Re: Soil, Geology and Geologic Hazard Evaluation
Joyful View Subdivision
Joyful View & Peyton Highway
Schedule Nos. 33000-00-466 & 33000-00-467
El Paso County, Colorado

PCD File # SF-22-31

SOILS MAP

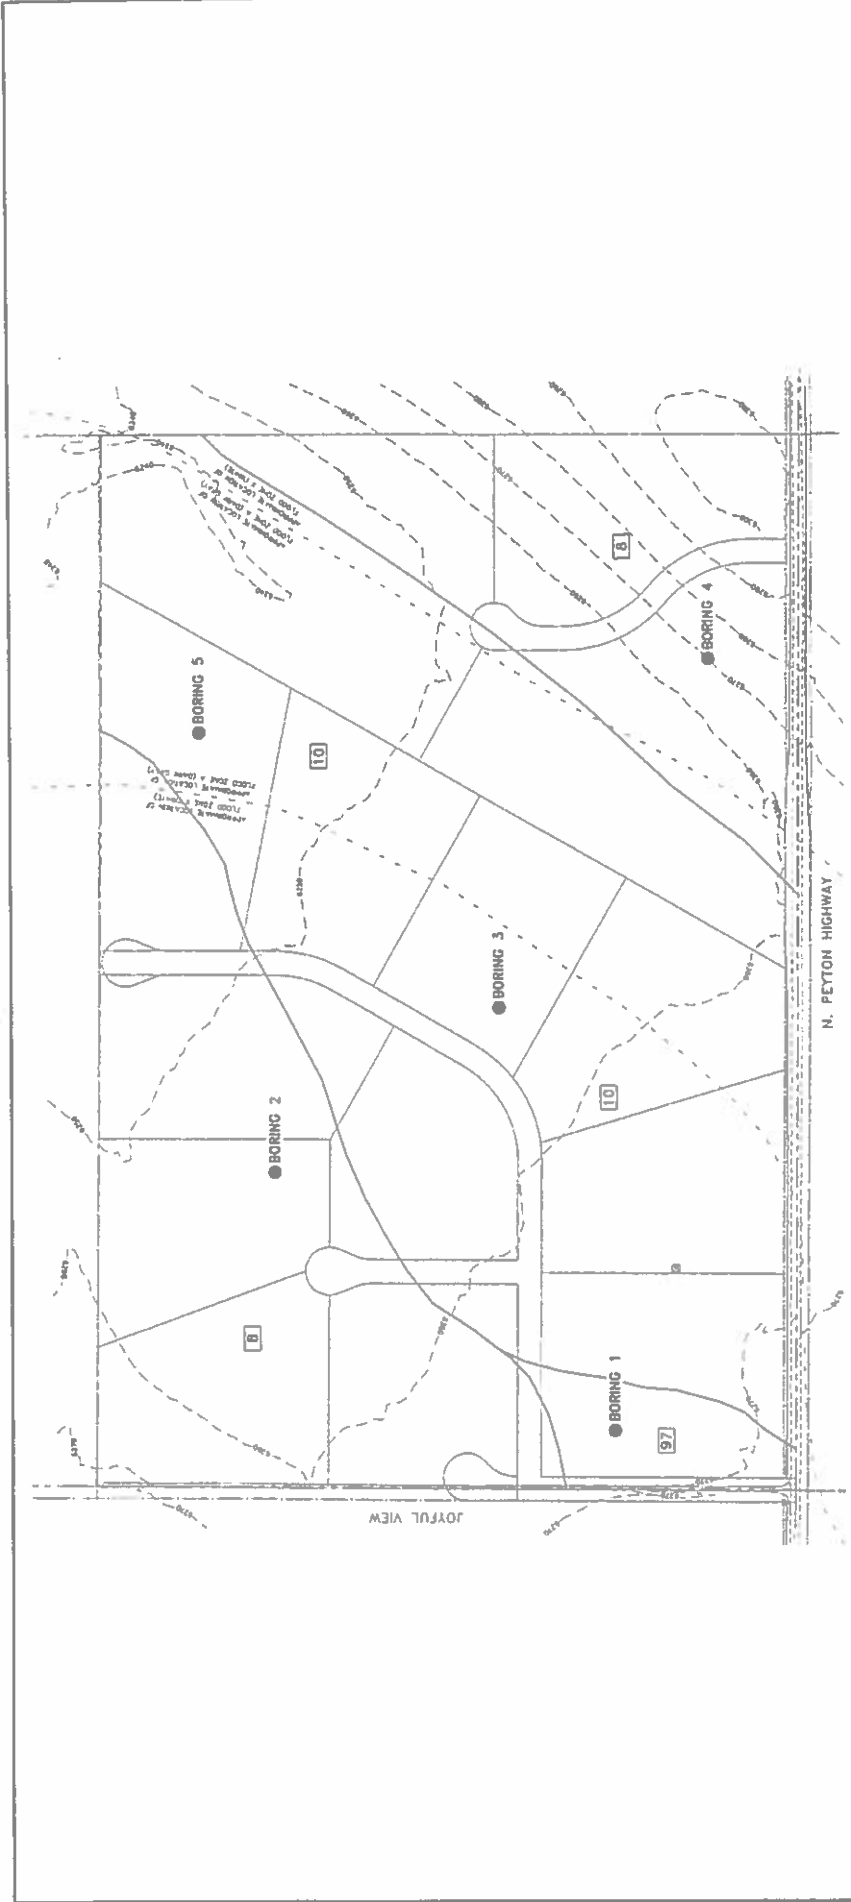
These are not correct development maps to reflect current lot layout and where boring holes correspond to/ Update all
